Bhutan Power Corporation Limited
(An ISO 9001:2015, ISO 14001:2015 & ISO 45001: 2018 Certified Company)
Registered Office, Thimphu
Procurement Services Department
Thimphu, Bhutan

BPC/PSD/2023 Materials/2022/11/667

Subject: Addendum No. 3

Reference: BPC/PSD/2023 Materials/2022/11 dated August 13, 2022

3 Phase Manual Changeover Switch Wiring Diagram

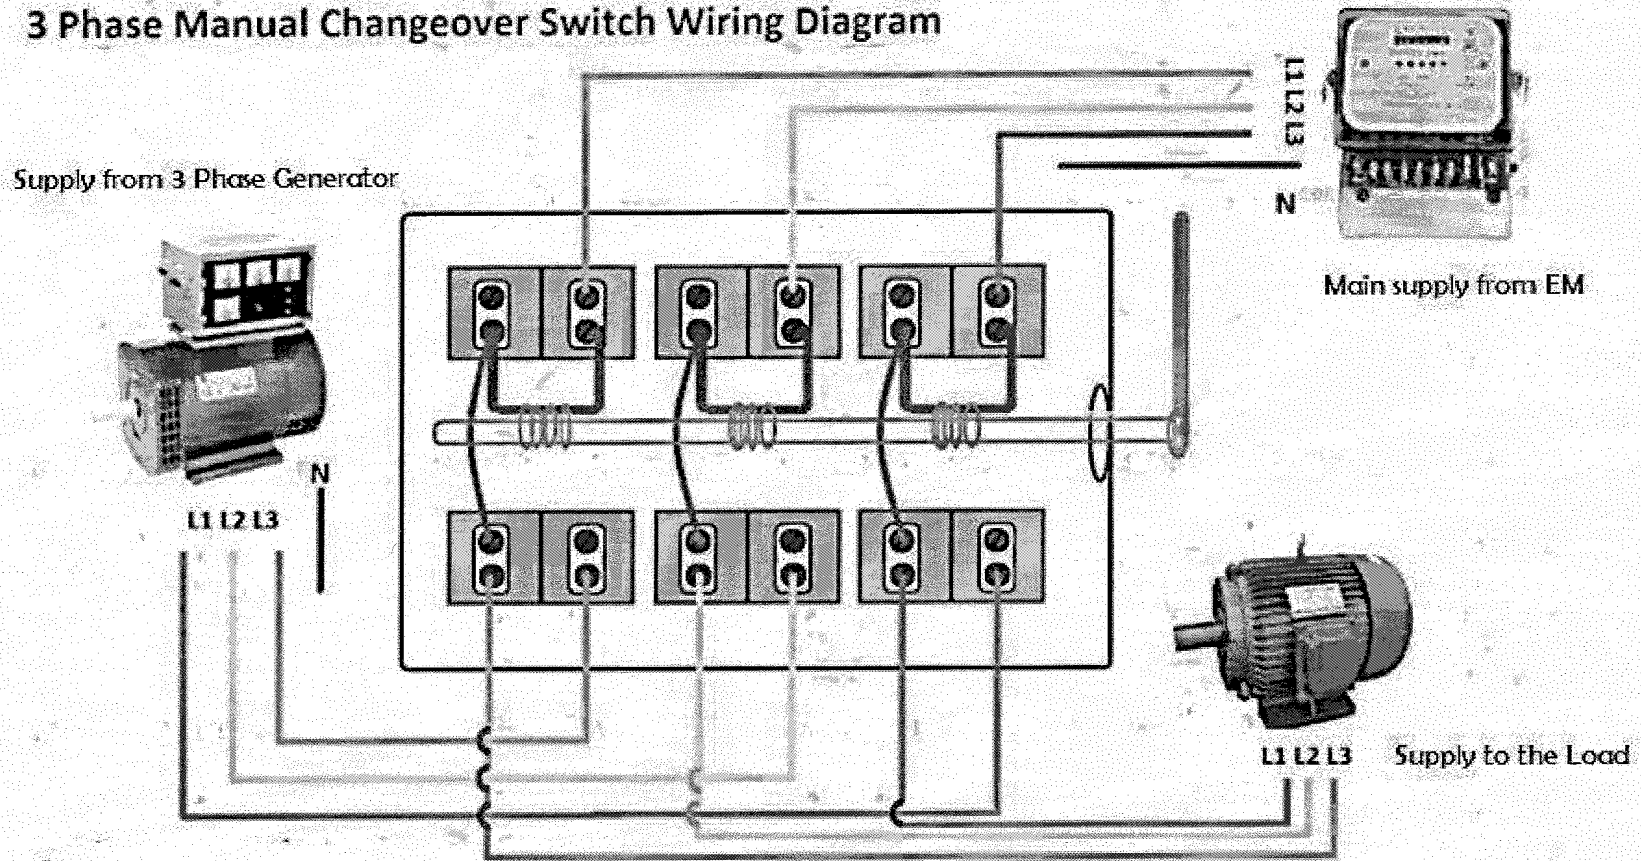
6. The **GTP** of Lot 7: Power Transformers is attached as *Annexure-4*. The same is updated in the Microsoft Excel format, please check serial No. 15 under Agency Documents on the website (www.tender.bt).
7. Please refer *Annexure-5* for the **Wiring Diagram of Item 2.33: Changeover Switch** under Lot 2: Pole Fittings.
8. **Technical Clarifications:** Queries received from the prospective Bidders and clarifications from the Purchaser are tabulated below:

Lot	Item	Queries	Clarification
Lot 2: Pole Fittings	Item 2.33: Changeover Switch	Which type is required to be supplied: 1. Box Type, 2. Side Handle Type, 3. Open Type?	Open Type
Lot 5: ARCB & Sectionalizer	General	Specify the quantity of Mobile workstation laptops required to be supplied.	Supply of Mobile workstation laptops and Training shall be excluded from Supplier's scope. Please check the revised Technical Specification attached as <i>Annexure-6</i> .
